Access Compliance Report

Public Rights-of-Way

(Curb Ramps)

Intersection ID: 14349	Main Street: REMOUNT_RD	Cross Street: TOOMEY_AV	Location:	N
ADA ID: 22B6F05943E8	Ramp Type: Perp	Initial Pass/Fail: Fail	Overall Compliance: No	Severity Score: 13.75
Codes/Mitigation Info/Possible Solution		Field Measurements/Component Compliance

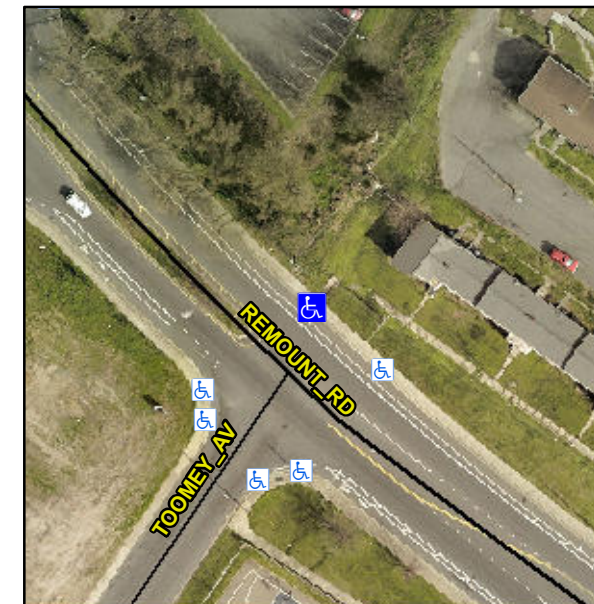
Compliance	Description	Data	Compliance	Description	Data
N/A	Ramp Length (in)	60.0	No	Ramp Slope (%)	10.9
Yes	Ramp Width (in)	61.0	Yes	Ramp XSlope (%)	4.2
N/A	Flare Type LT	N/A	N/A	Flare Type RT	N/A
N/A	Flare Slope LT (%)	N/A	N/A	Flare Slope RT (%)	N/A
N/A	Flare Traversable LT?	N/A	N/A	Flare Traversable RT?	N/A
N/A	Landing Length (in)	N/A	N/A	DWS Provided?	N/A
N/A	Landing Width (in)	N/A	N/A	DWS Contrast?	N/A
N/A	Landing Slope (%)	N/A	N/A	DWS Length (in)	N/A
N/A	Landing X Slope (%)	N/A	N/A	DWS Full Width?	N/A
N/A	Landing Curb? (Y/N)	N/A	N/A	DWS Offset (in)	N/A
N/A	Shared Landing?	N/A			
N/A	Gutter Ponding?	N/A	N/A	Gutter Slope (%)	N/A
N/A	Gutter Lip Ht (in)	N/A	N/A	Gutter X Slope (%)	N/A
N/A	Painted X Walk1?	No	N/A	Painted X Walk2?	N/A
	X Walk 1 Direction	To SW		X Walk 2 Direction	N/A
N/A	X Walk 1 Width (in)	N/A	N/A	X Walk 2 Width (in)	N/A
	X Walk 1 Slope (%)	7.2		X Walk 2 Slope (%)	N/A
	X Walk 1 X Slope (%)	4.6		X Walk 2 X Slope (%)	N/A

Remove & Replace Entire Ramp.
